# DISCRETIONARY REVIEW ABBREVIATED ANALYSIS

**HEARING DATE: April 29, 2021**

**Record No.:** 2021-000389DRP  
**Project Address:** 366-368 Collingwood Street  
**Permit Applications:** 2020.1120.9381  
**Zoning:** RH-2 [Residential-House, Two Family]  
40-X Height and Bulk District  
**Block/Lot:** 2751/ 036, 037  
**Project Sponsor:** Jamie Maestro  
101 Broadway #309  
Oakland, CA 94607  
**Staff Contact:** David Winslow – (628) 652-7335  
[david.winslow@sfgov.org](mailto:david.winslow@sfgov.org)

The project proposes to expand the roof decks at two upper units of the three-family home.

**A2.4**

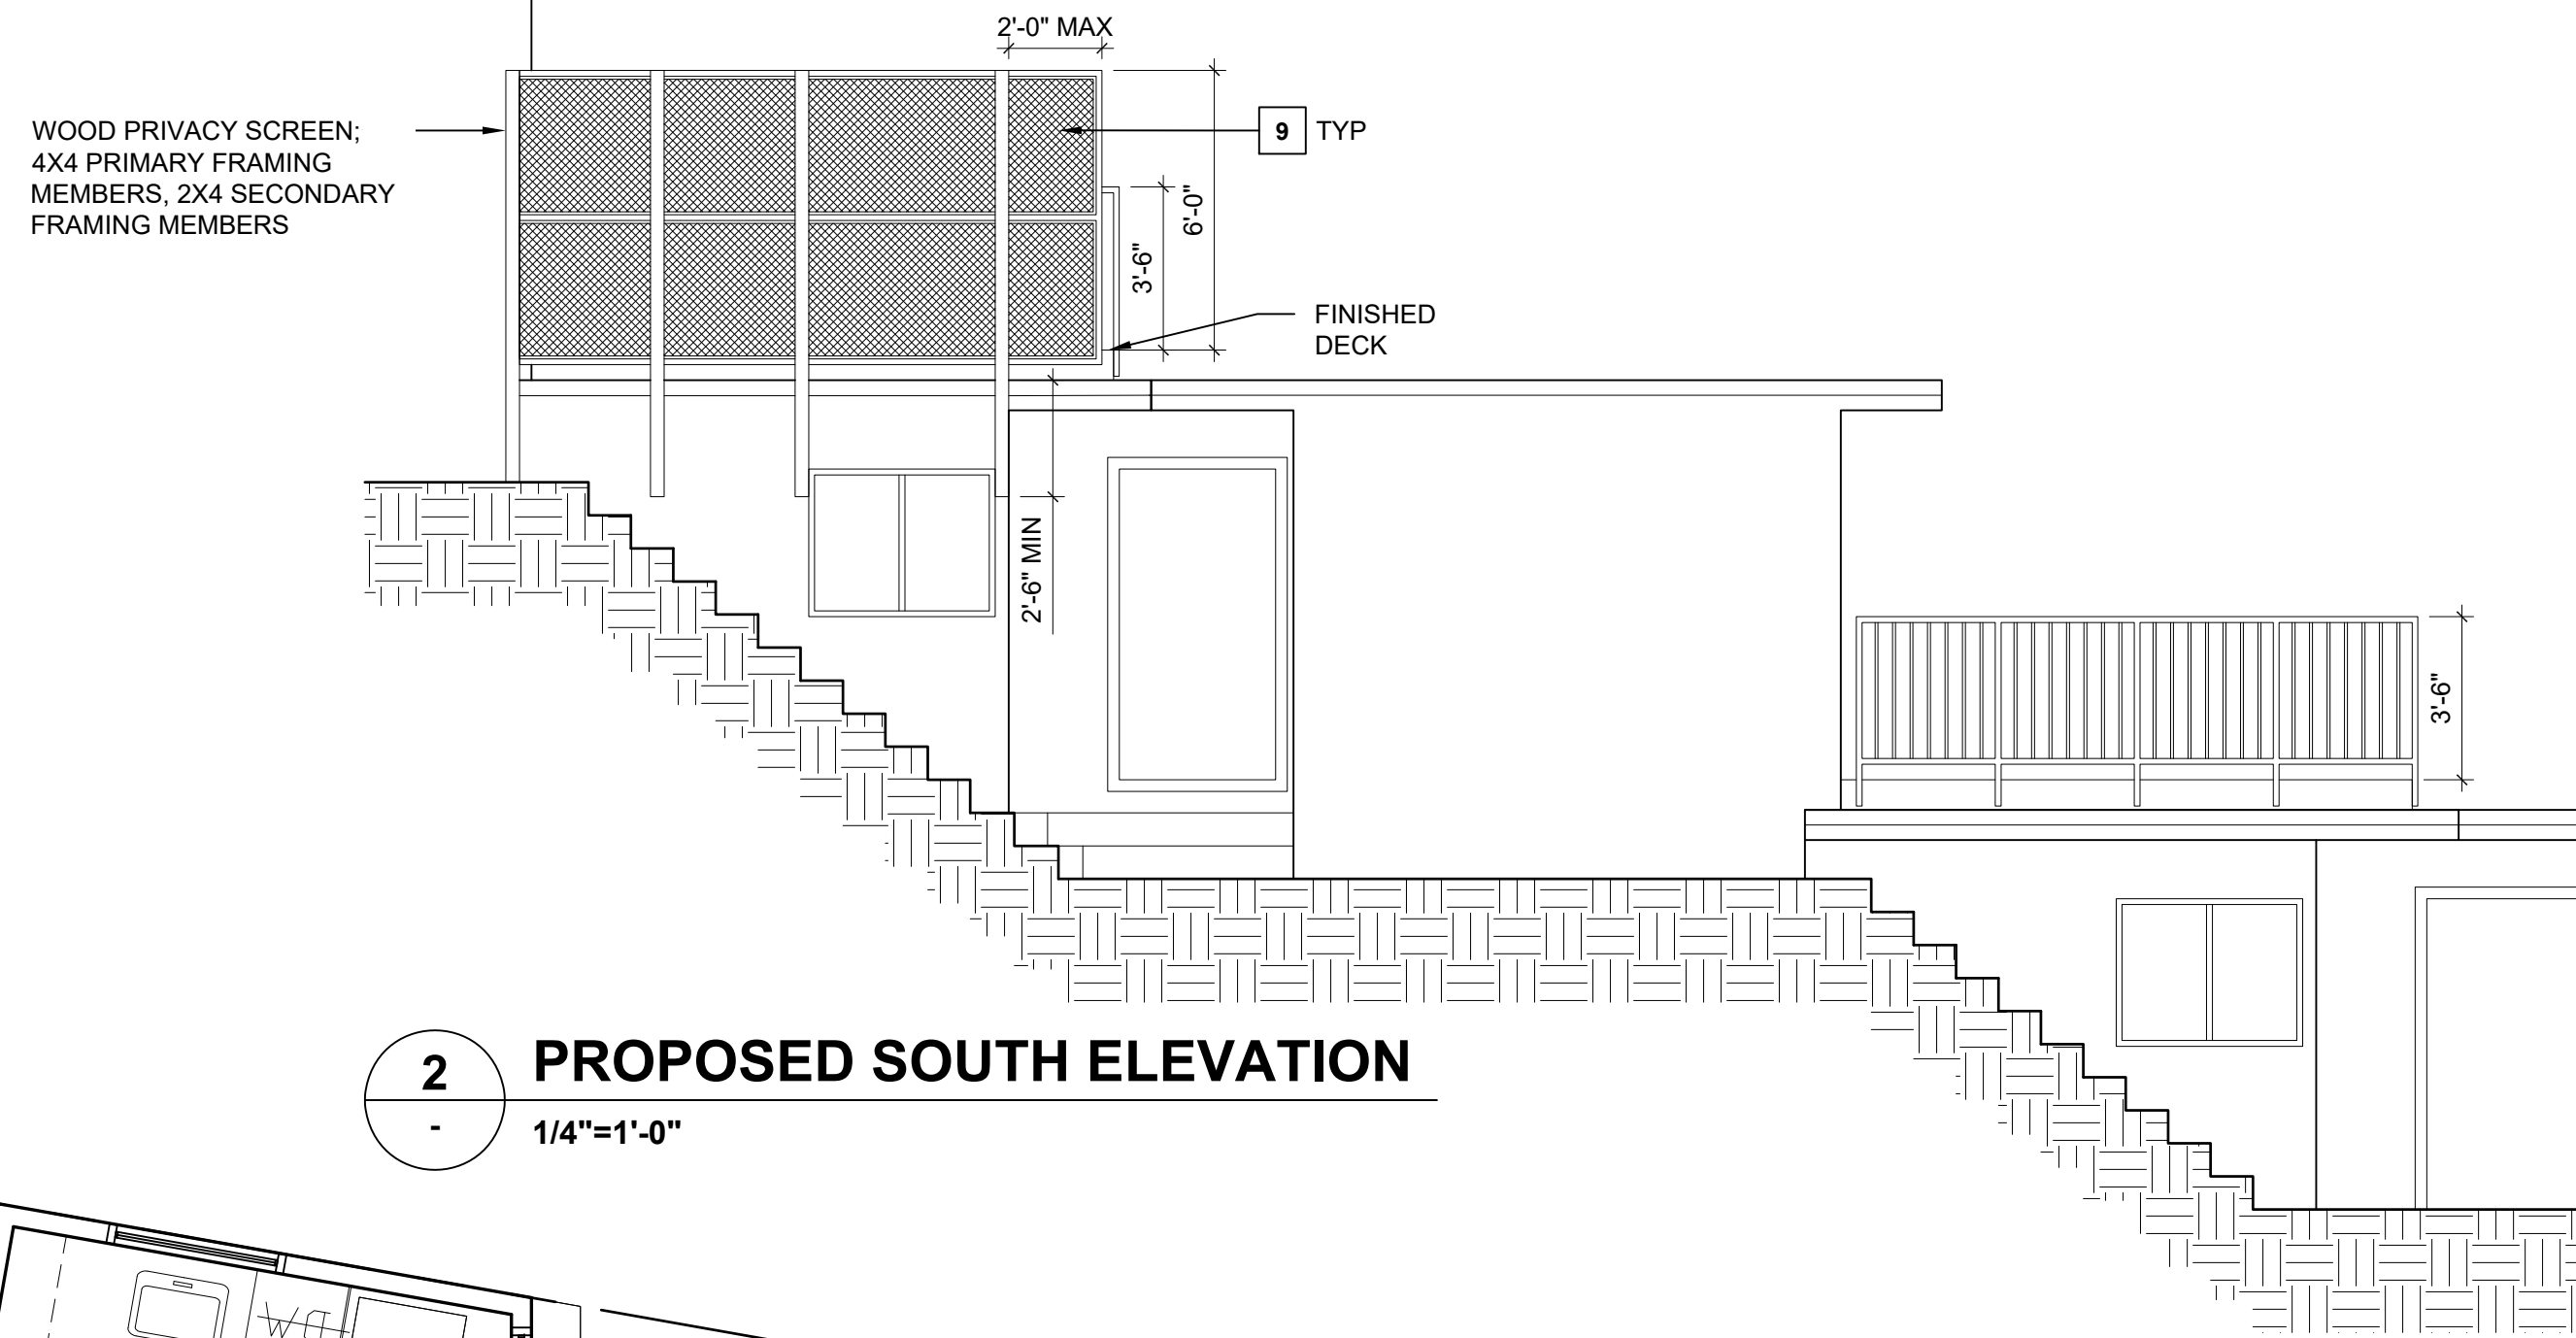
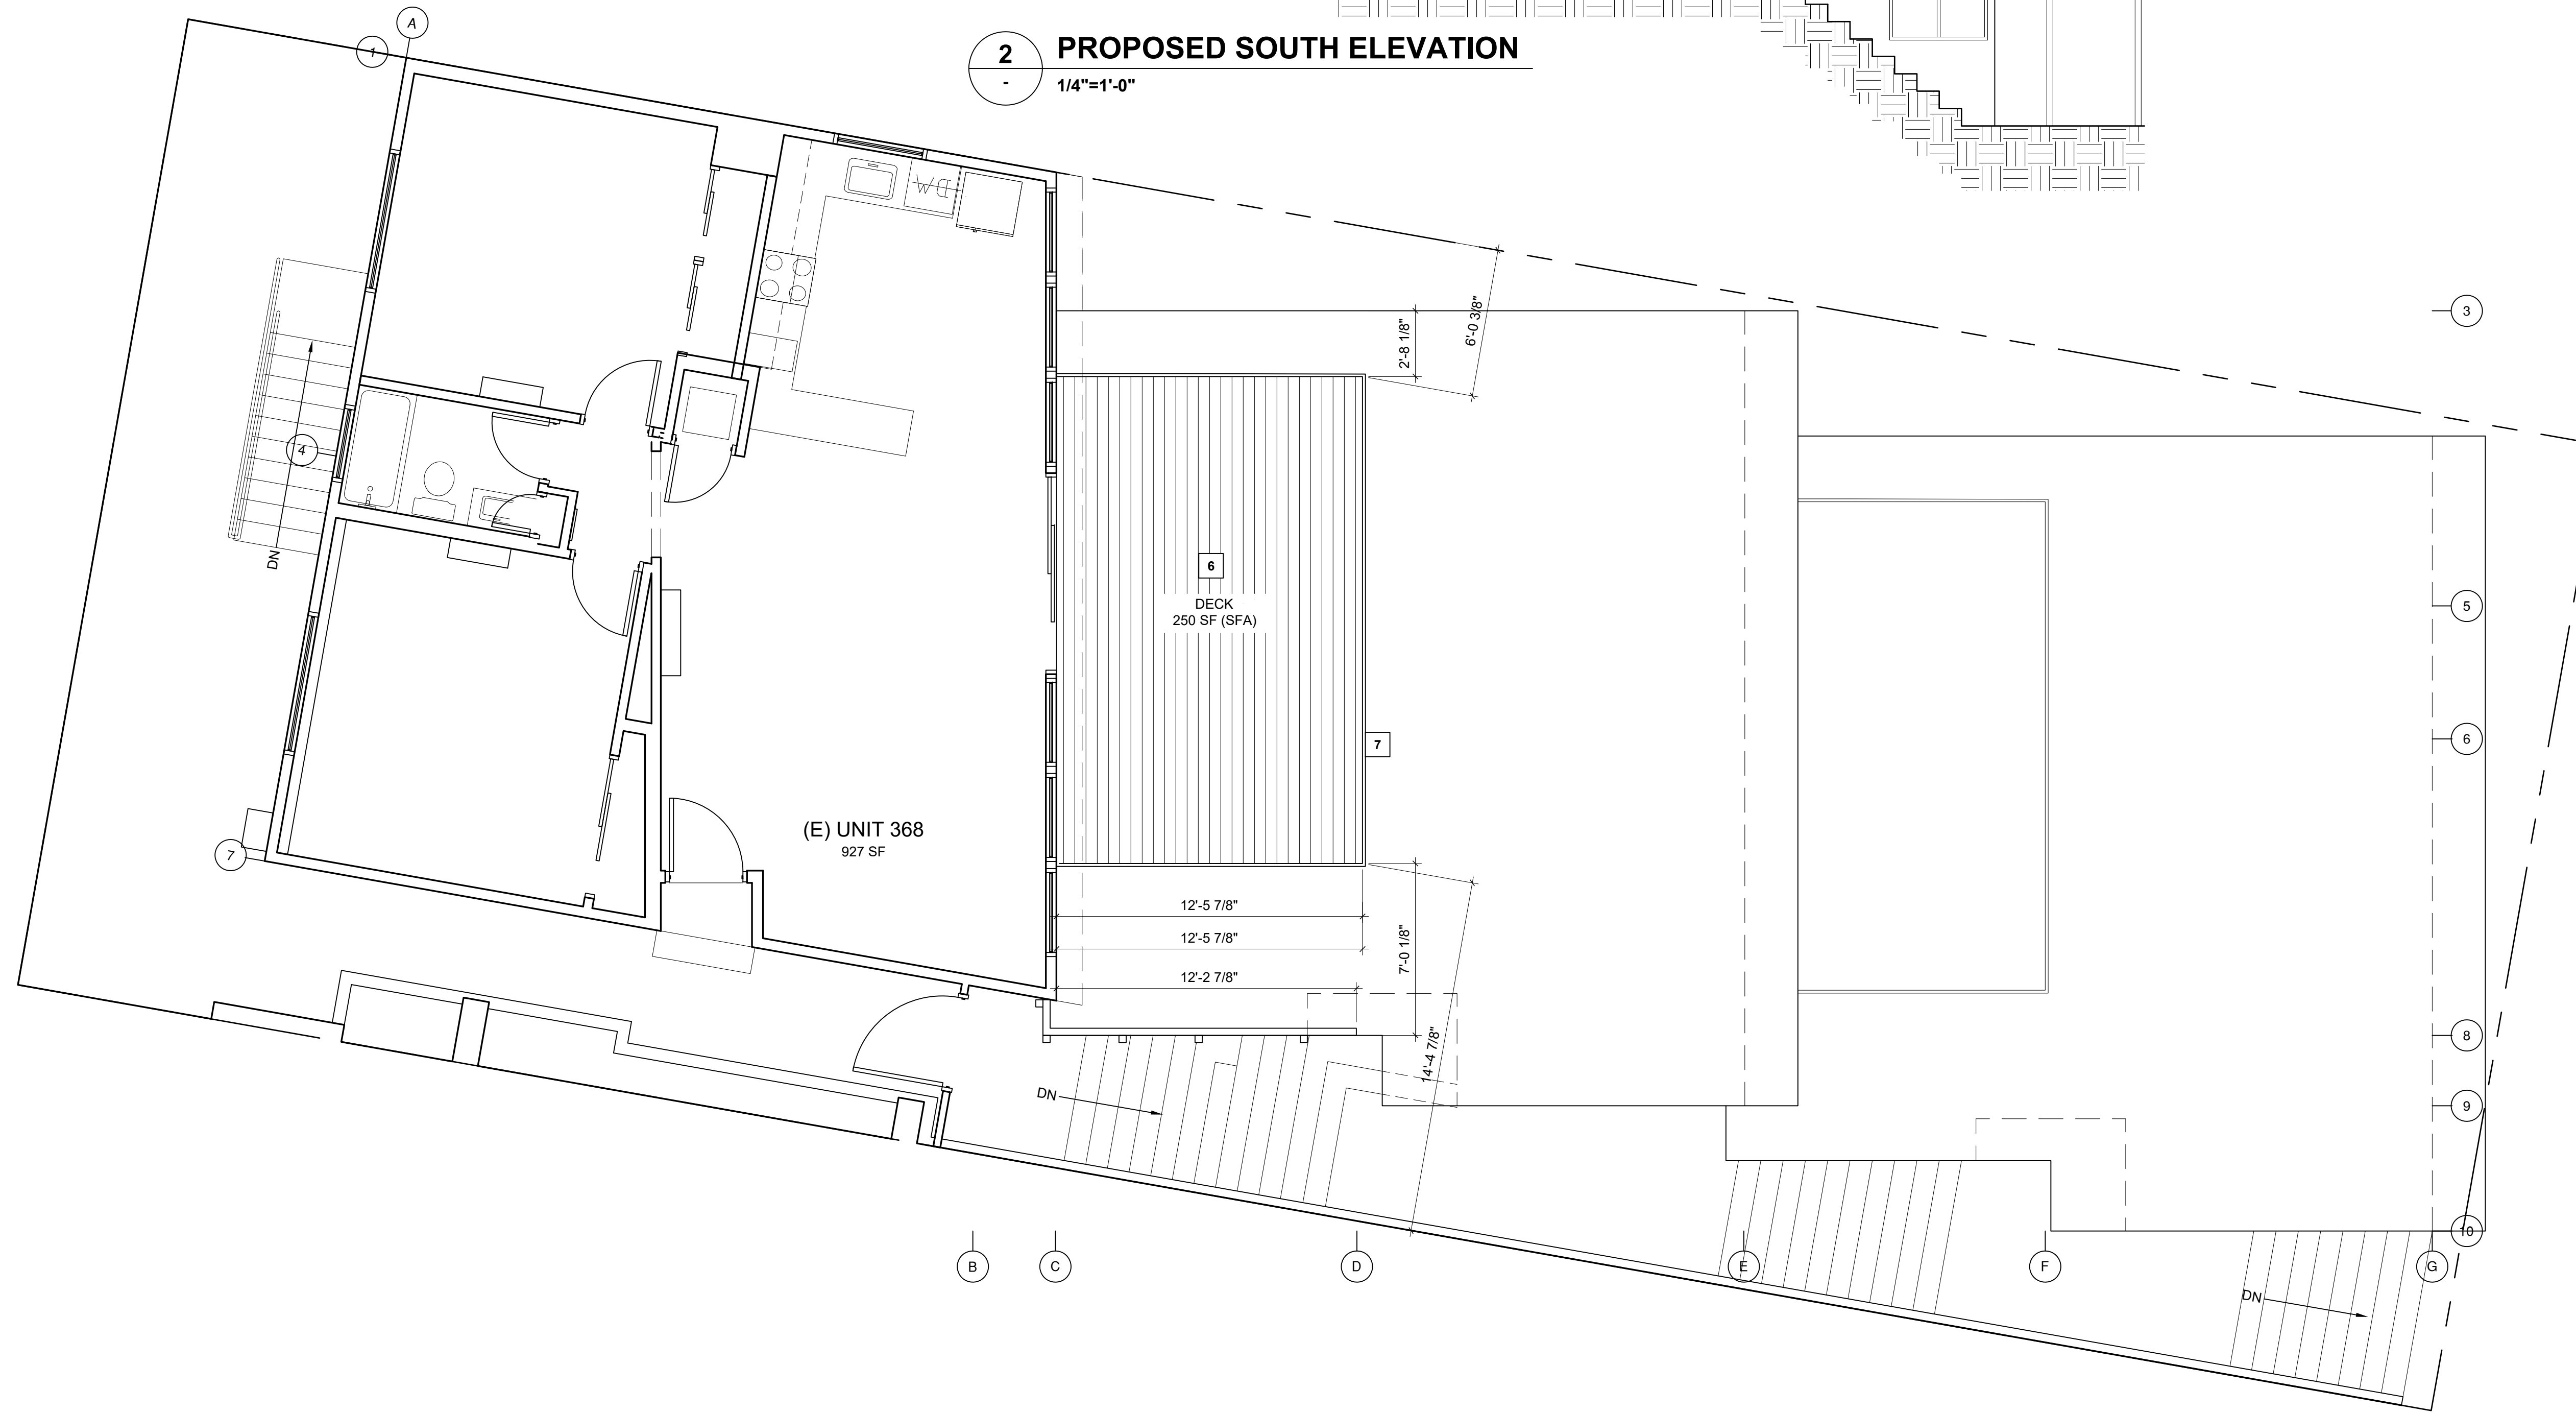
Is concerned that the proximity of the decks will impact privacy to his apartment.

The DR requestor and Project sponsor have reached an agreement that they would like to have memorialized by taking DR. The project sponsor has modified the design of the roof decks from the original plans to:

- 1) Set the third-floor deck 7’-0” from the south edge of the roof;
- 2) Set the second-floor deck 6’-6” from the south edge of the roof and;
- 3) Provide a 6’ high privacy screen at the south roof edge of third floor deck

The project has been revised to set the decks back from the building edge and provide a privacy screen from the third-floor deck.
